Crown Pastoral Land Tenure Review

Lease name: BARROSA

Lease number: PC 125

Public Submissions - Part 5

BARROSA PASTORAL LEASE

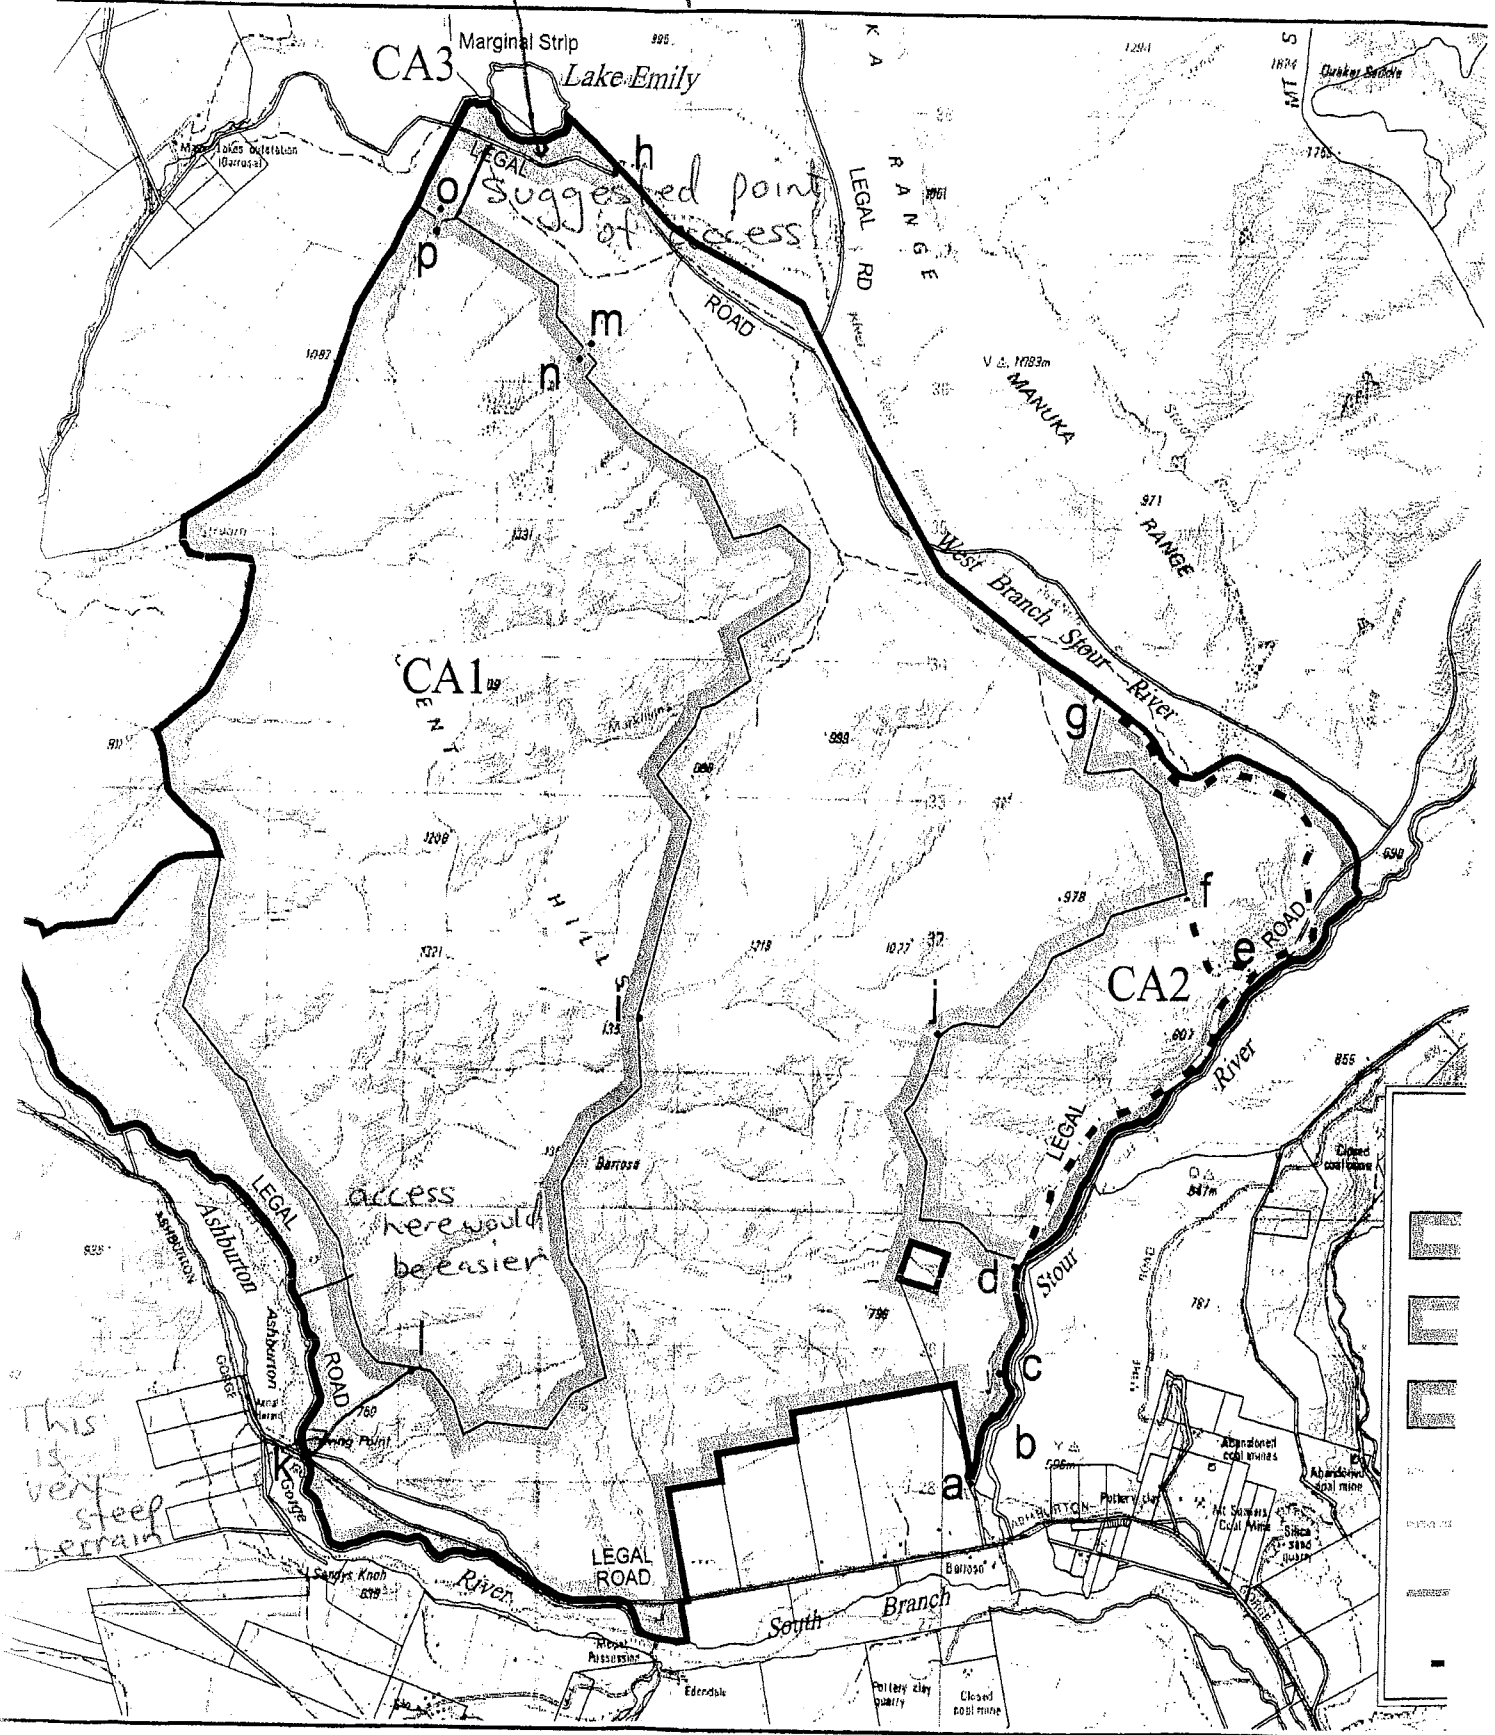
I have a copy of the proposed land division and I am concerned to see that there appears to be very limited access to the main Block CA1. I would consider myself to be a reasonably fit and able person but I would suggest to you that the two points of access to this block will both be difficult to use, going by the contours on the map. Unless this Block CA1 is made more accessible, many people who may wish to visit this area will simply not be able to.

There is a solution, which appears to be reasonably obvious. Another point of access is required at the North end of this Block CA1 somewhere near Lake Emily. In addition, the access from the Blowing Point end could also be improved by taking it slightly further North and up onto the Block CA1 through some easier terrain.

I have enjoyed visiting Lake Emily several times and look forward to the protection that the area CA3 will give to this lake. When out fishing, I have often observed damage around lakes and waterways caused by farm animals. The area of protection around this lake is quite small and should be made larger.

more protection at this point.

BARROOSA PASTORAL LEASE

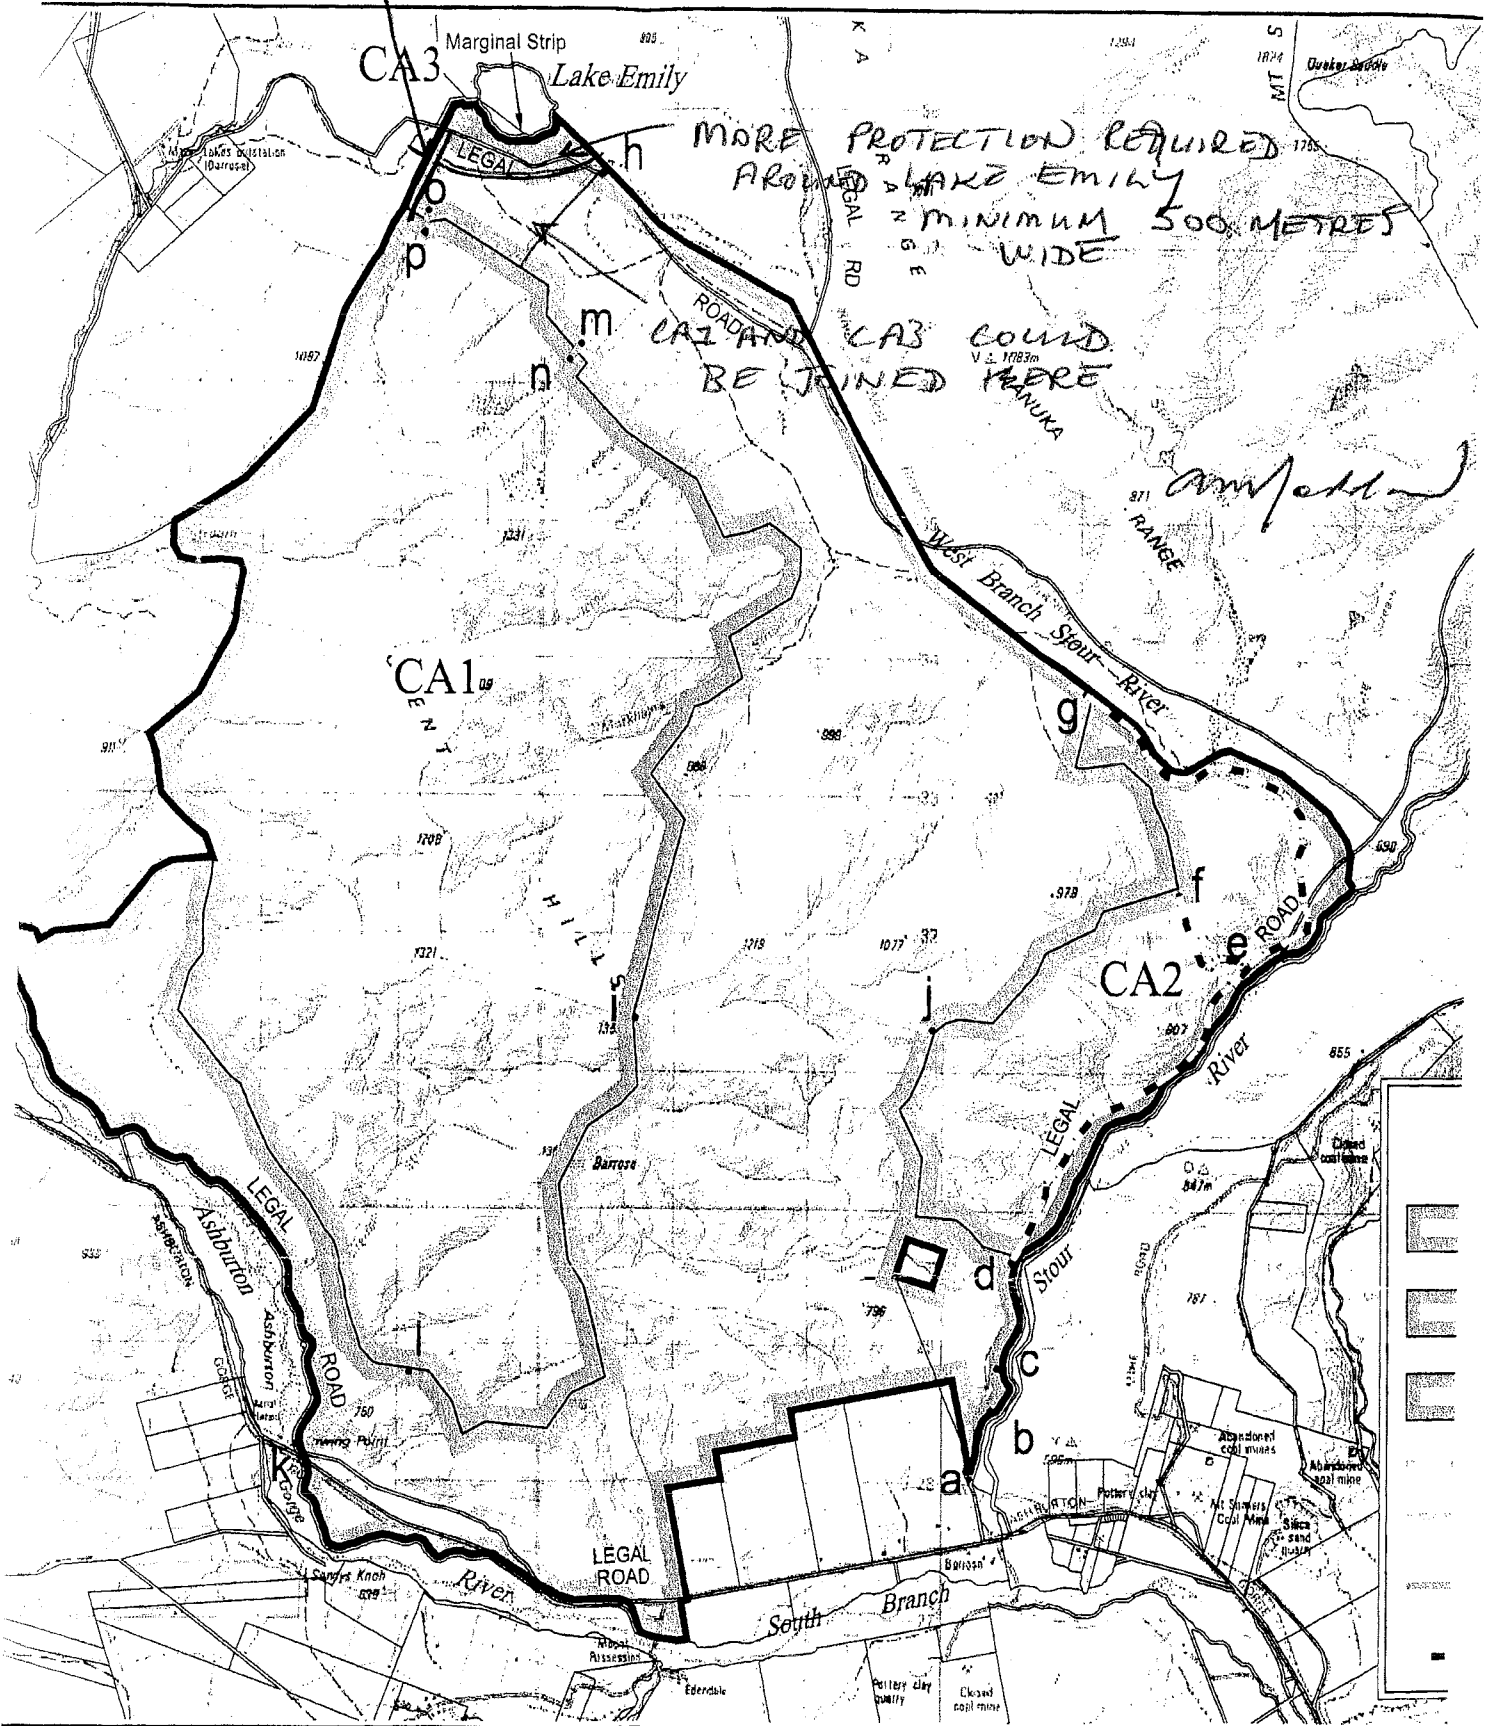
The current proposal gives access to the block CA1 at two places. Both of these points of access are located in the Southern third of the block and neither of them would be very easy to traverse. The track at Blowing Point from K to L goes up through very steep terrain and one would have to cover a very long distance to get to the access point situated at I.

There is no access to CA1 at the North end.

I suggest that another point of access to CA1 be made at the North end of this block.

1. Create access across the land to be freeholded, next to the boundary fence, which runs South West from Lake Emily and near the water easement O-P.
2. Create access by connecting the block CA1 to the Conservation land CA3 in the area next to Lake Emily where the separation between these blocks is only approximately 500 metres.

There is insufficient Conservation land around the shores of Lake Emily.

Past experience clearly demonstrates that wetland areas around these small Lakes are easily damaged by grazing animals. The Conservation land around this Lake should be a minimum of 500 metres wide to adequately protect this environment.

CREATE ADDITIONAL
ACCESS HERE TO CA1
